FIRE SAFETY INSPECTION REPORT

Factory Name: Nassa Spinners and Garments Ltd

Inspected By: Mohammad Atick Al Zaman & Ahammad Kabir
Date: 25th July, 2019

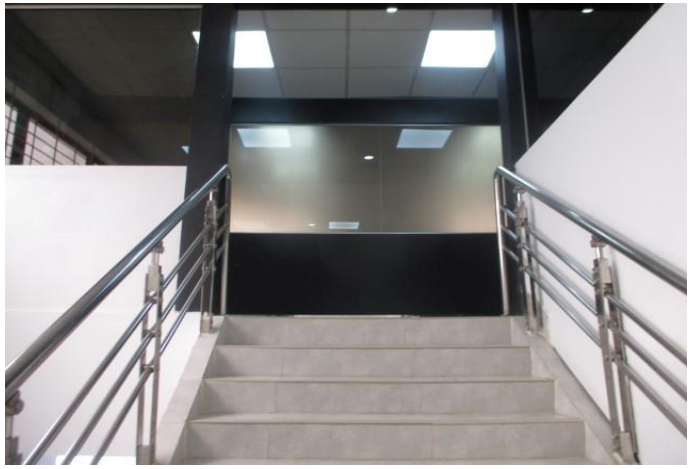
Sl No.	Category	Findings	Required Action	Remediation Time Frame
F-1	Fire Rated Construction	The exit stair enclosures are separated from work areas and other spaces on each floor by fire-rated construction. Fire Doors have been provided with proper hour rating. But doors are kept open and installation of magnetic hold open device to interface with Fire Alarm System have been done but the devices are not interfaced with any approved FACP. Moreover Exit stair enclosures have unprotected openings within 10 feet towards production floor at two stairs.	The exit stair enclosure shall be provided with a minimum 1-hr fire resistance rating for buildings with 3 or fewer stories and a minimum of 2- hr. fire resistance rating for buildings 4 or more stories. Provide 0.75 hr. fire rated door and seal all penetrations and openings by 1 hr. fire rated fire rated barrier construction for building with 3 or fewer stories. Provide 1.5 hr. fire rated door and seal all penetrations and openings by 2 hr. fire rated fire rated barrier construction for building with 4 or more stories. Provide a fire-resistive rated assembly between the exterior exit stairs and the building up to 10 ft. beyond the end of the stair to achieve the required separation. The rated assembly shall be approved and/or designed by a qualified fire protection engineer. Ensure that the fire doors are self-closing and positive latching and that they are provided with fire exit (panic) hardware where serving production floors. If fire doors are	Within 3 months

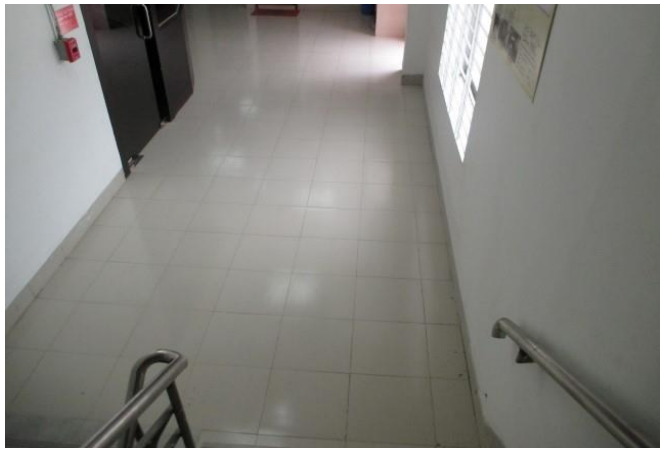
F-2	Interior Exit Discharge	Exit stair(s) is discharge the occupants inside the building.	1. Modify stair to discharge directly outside. Or 2. Provide 2-hr fire-rated exit passageway leading directly outside (vestibules to separate any storage areas). Or 3. Provide sprinkler protection for discharge floor in accordance with NFPA 13.	Within 3 months
